# **ADDENDUM NUMBER: ONE [1]**

PROJECT: Provalus Whiteville

DATE: November 20, 2024

Drawings and Project Manual dated <u>October 30, 2024</u>, for this project are hereby modified, corrected, or supplemented as follows:

Sheet Title
OVERALL BUILDING
ELEVATIONS

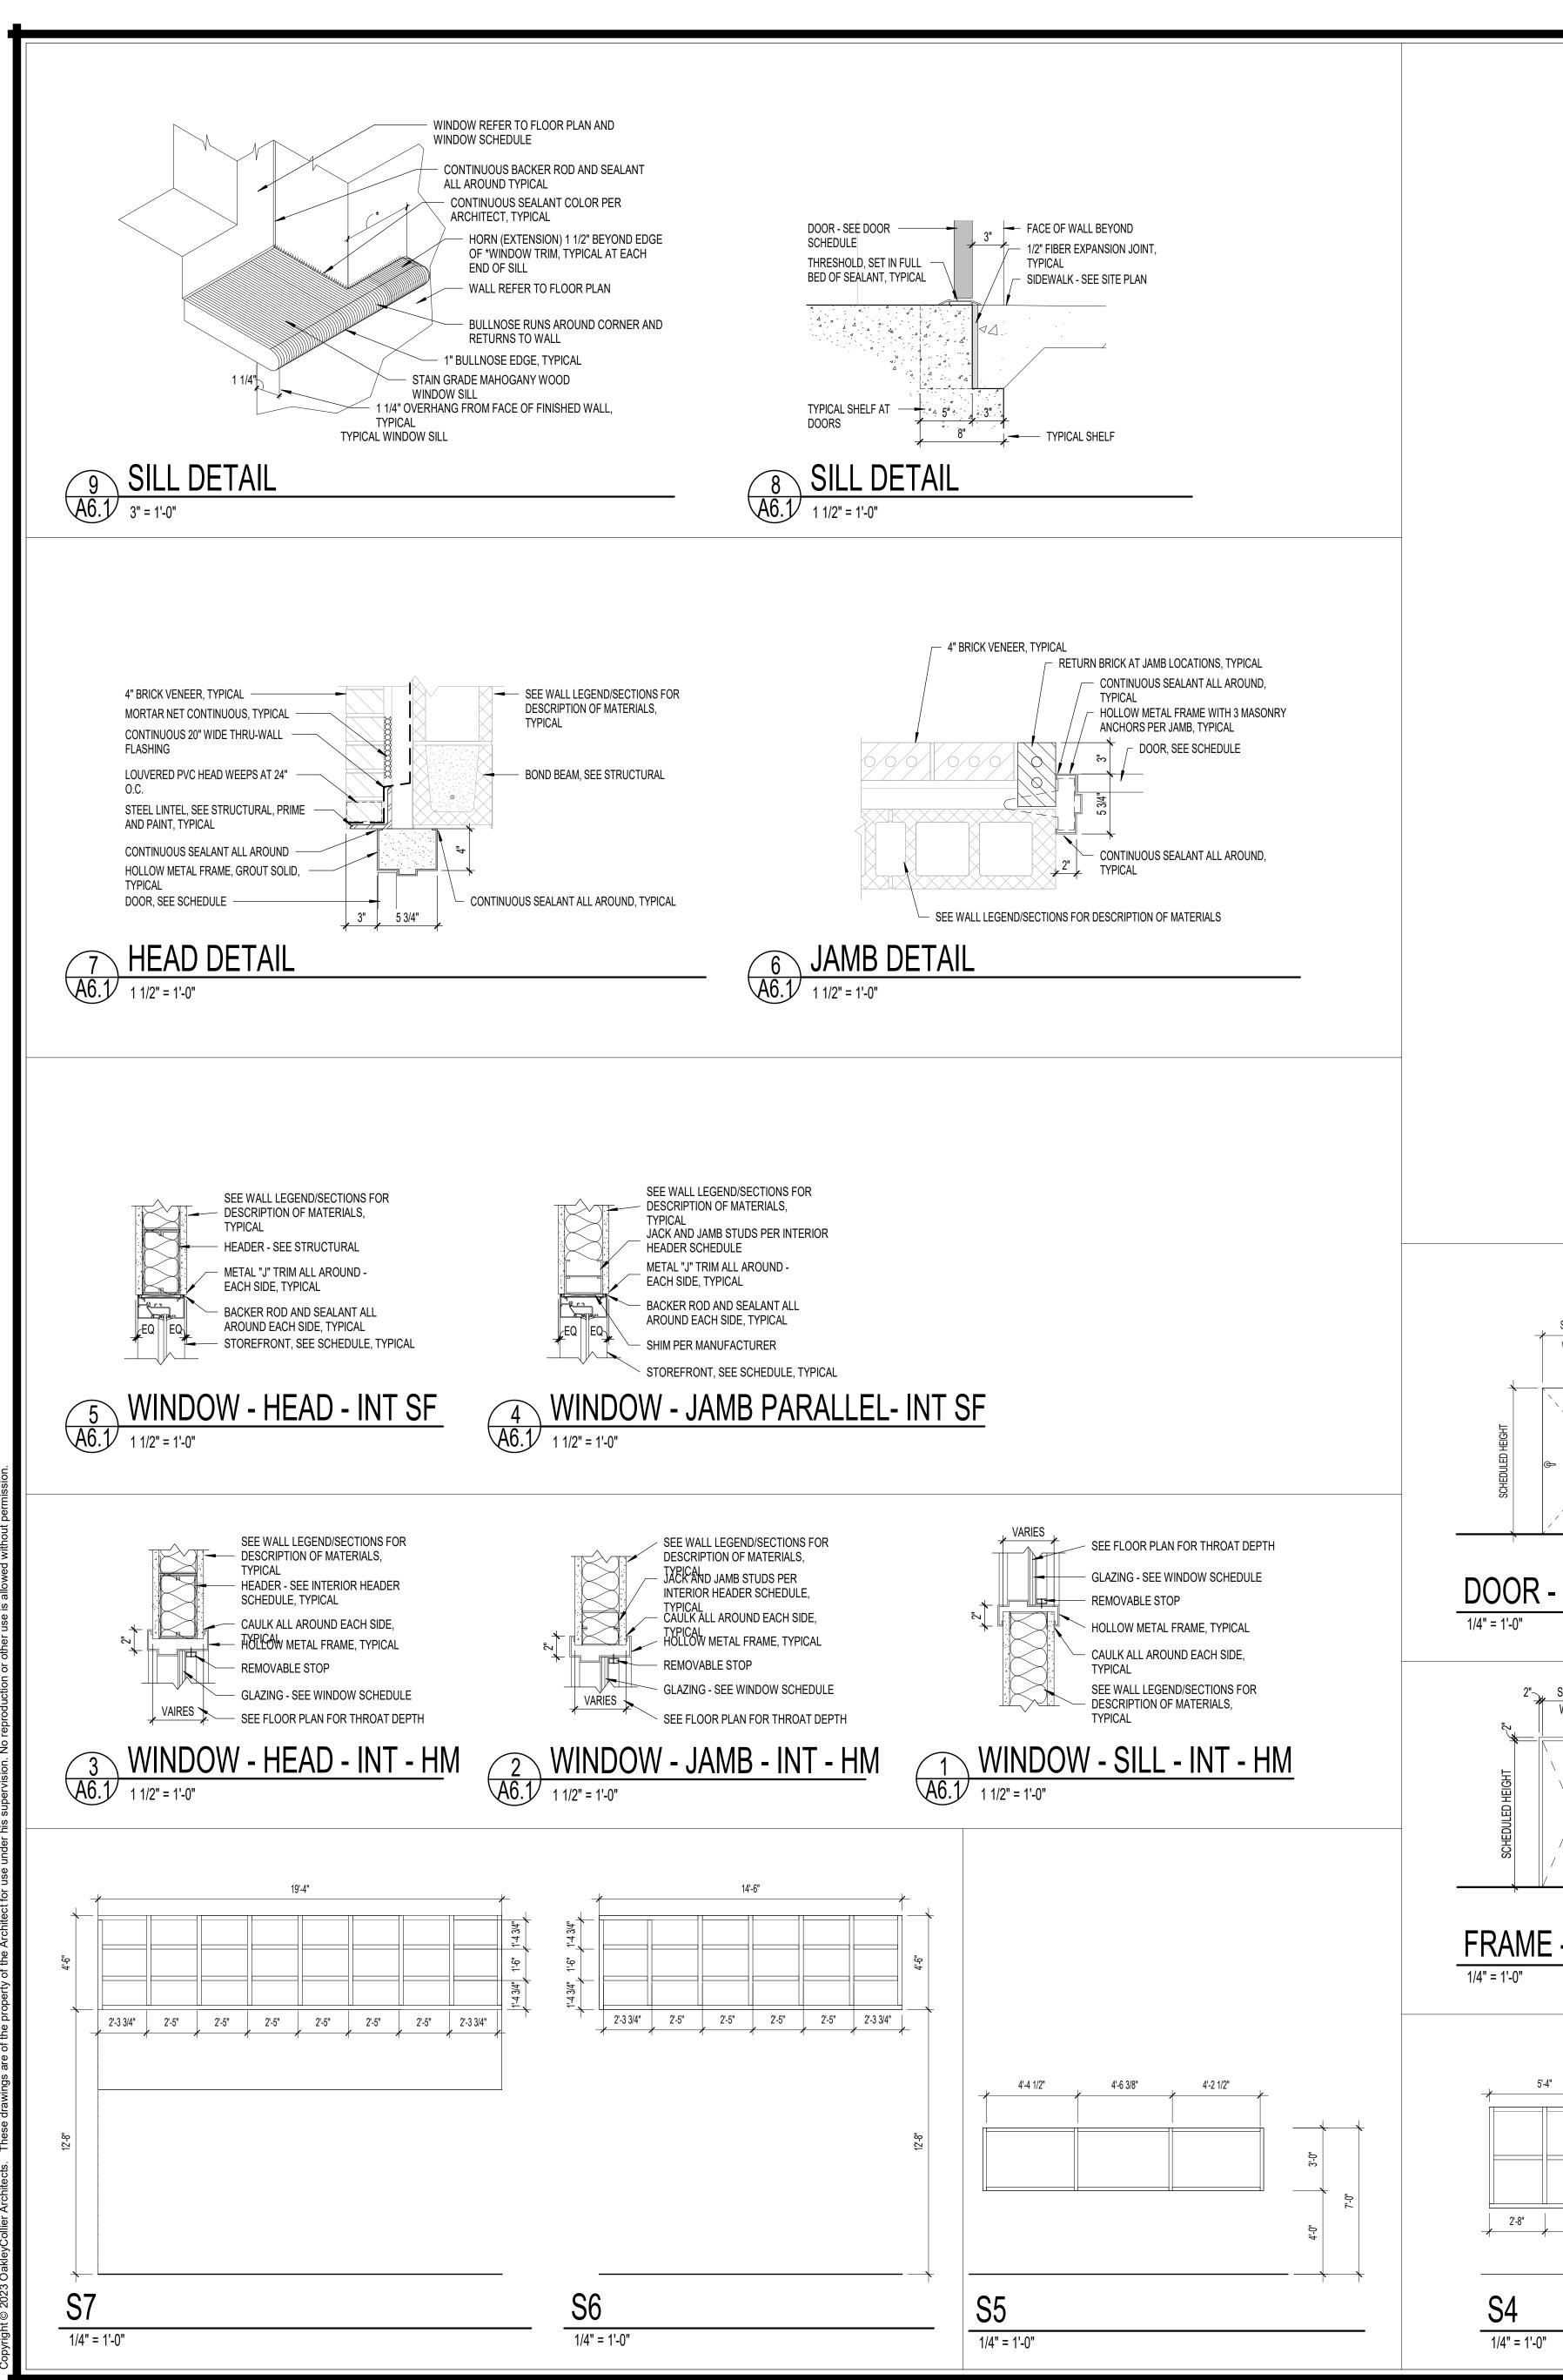
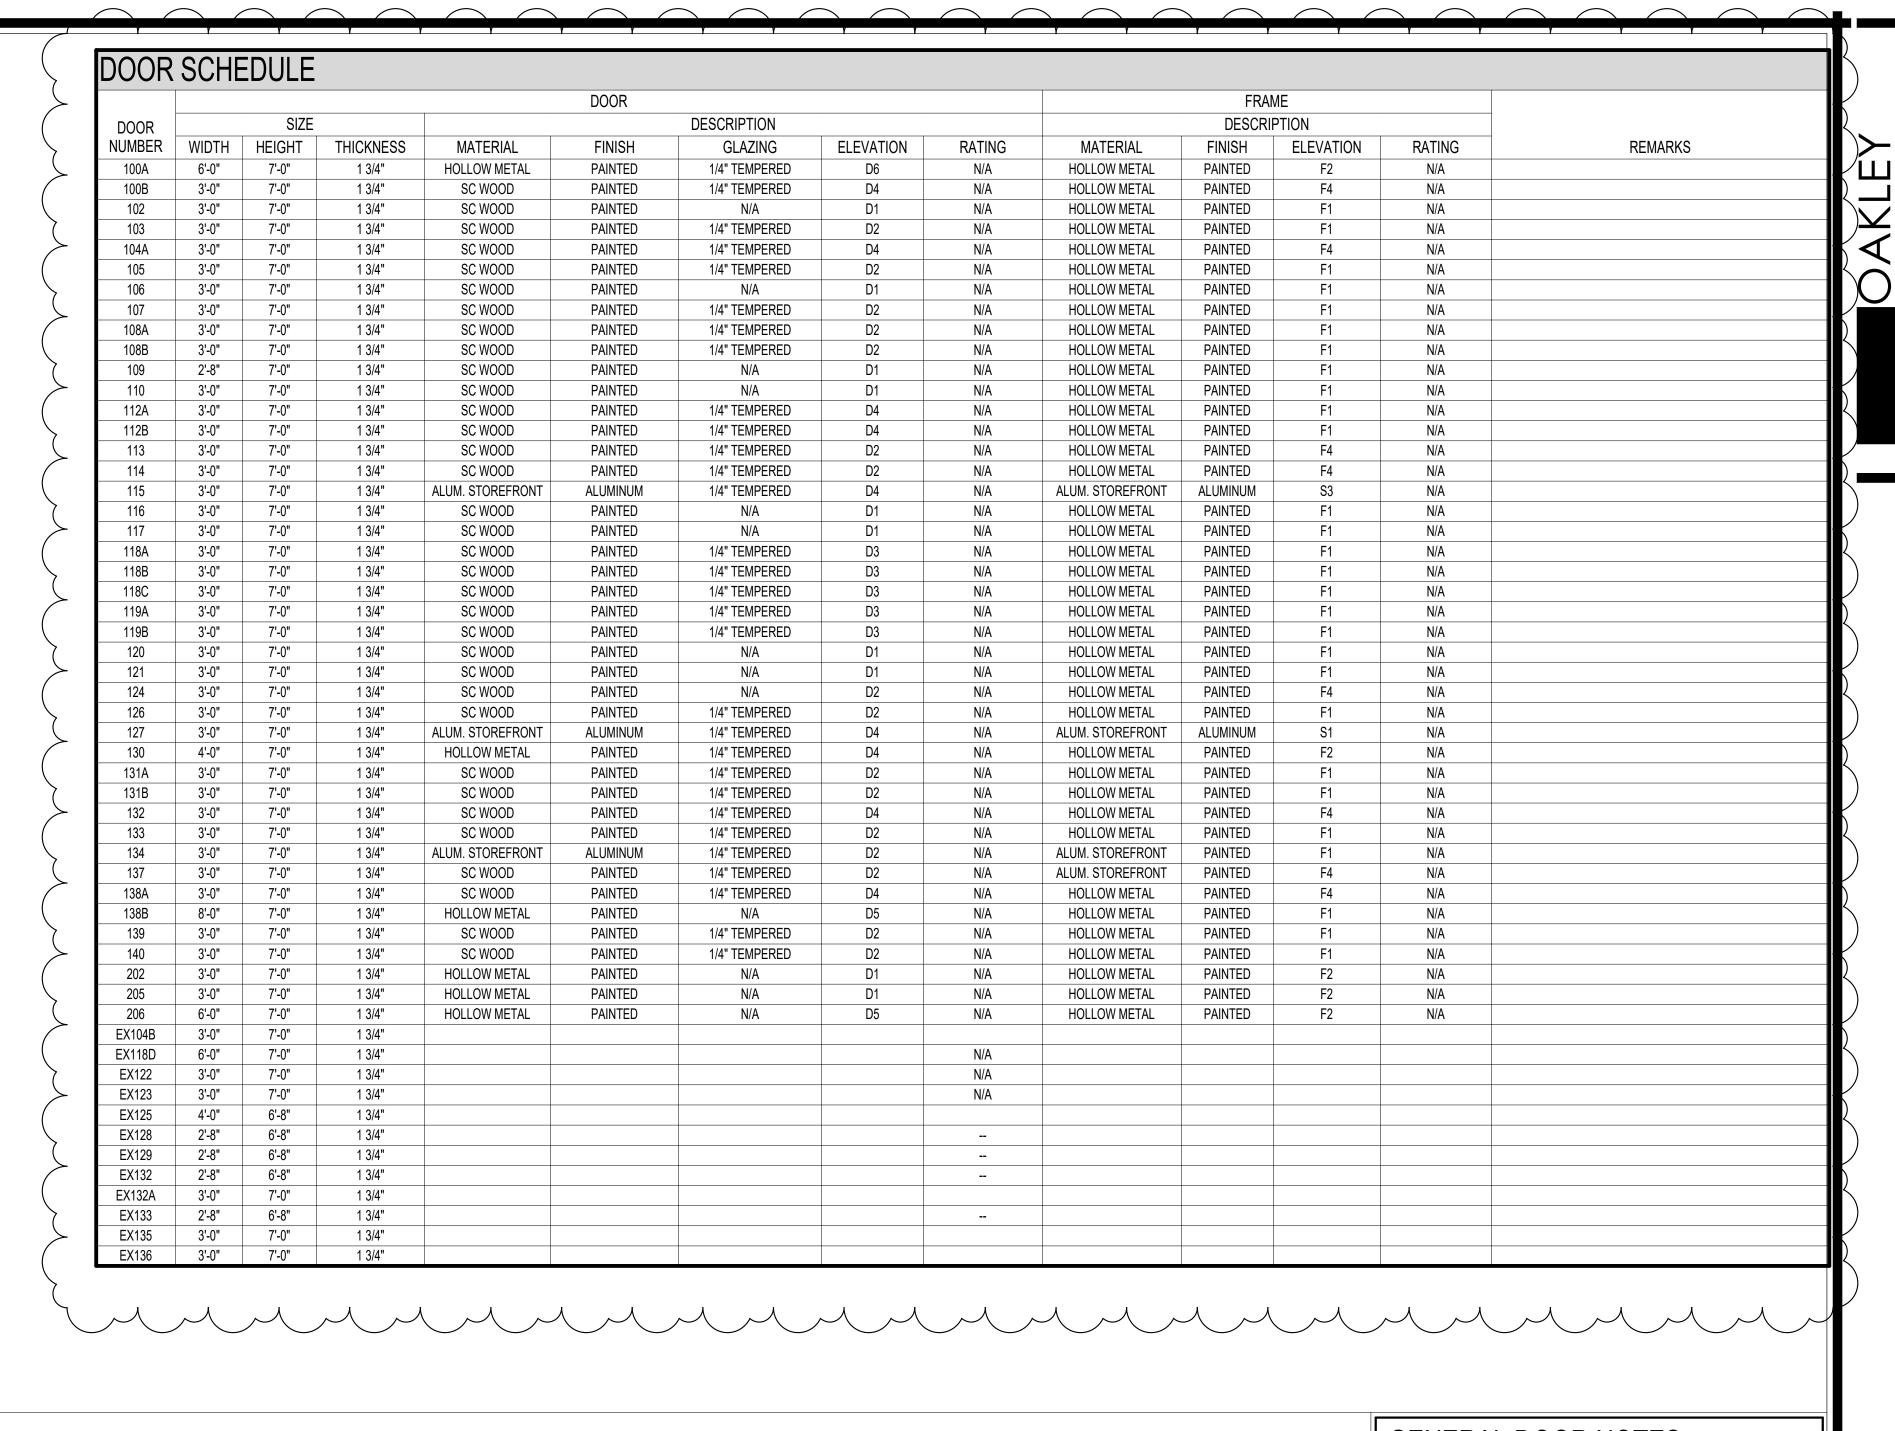
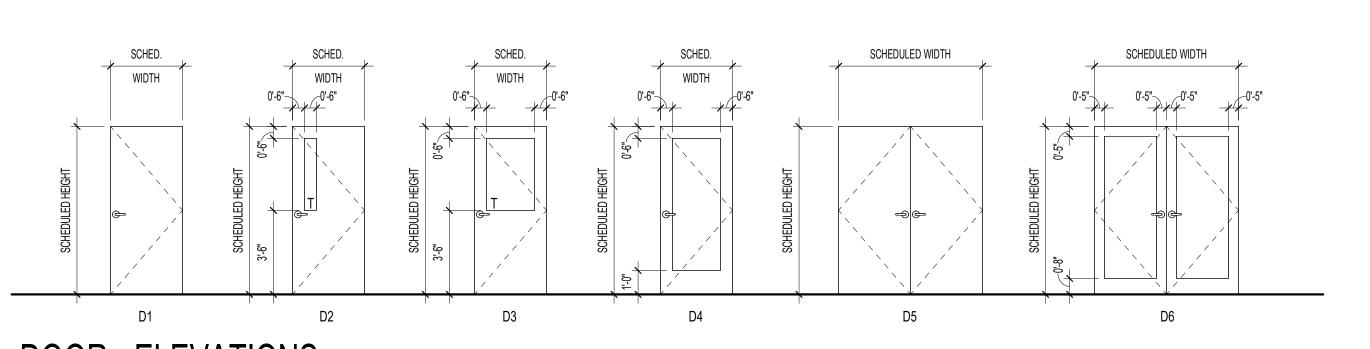
Item 9 Revision Sheet A2.0 – Overall Building Elevations

Window tags W1 renamed to S8

Checked By DG DOOR AND WINDOW SCHEDULE

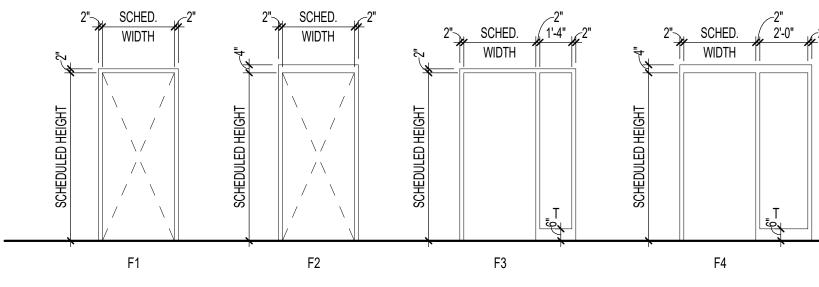
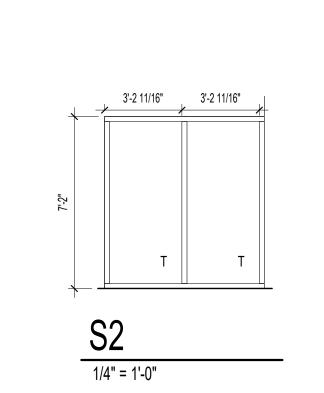
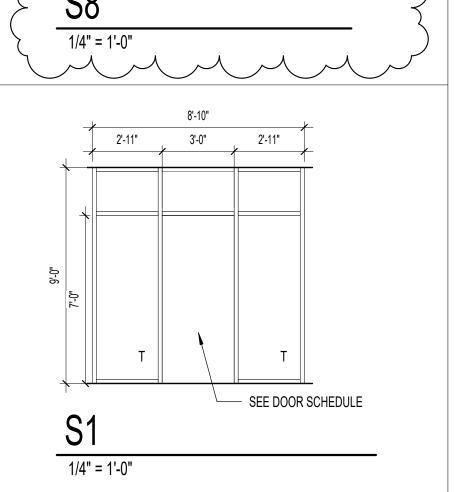
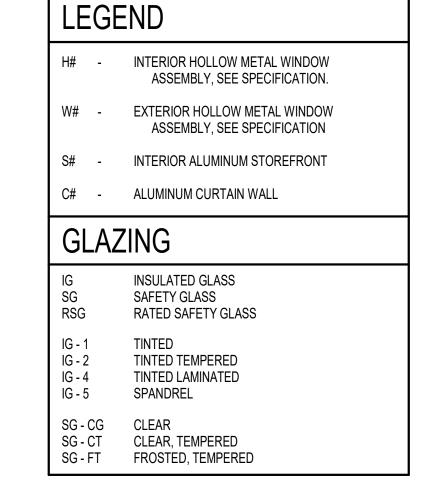
Item <u>10</u> Revision Sheet A6.1 – Door and Window Schedule

Window type W1 renamed to S8

Updated to indicate no painted aluminum window or door frames
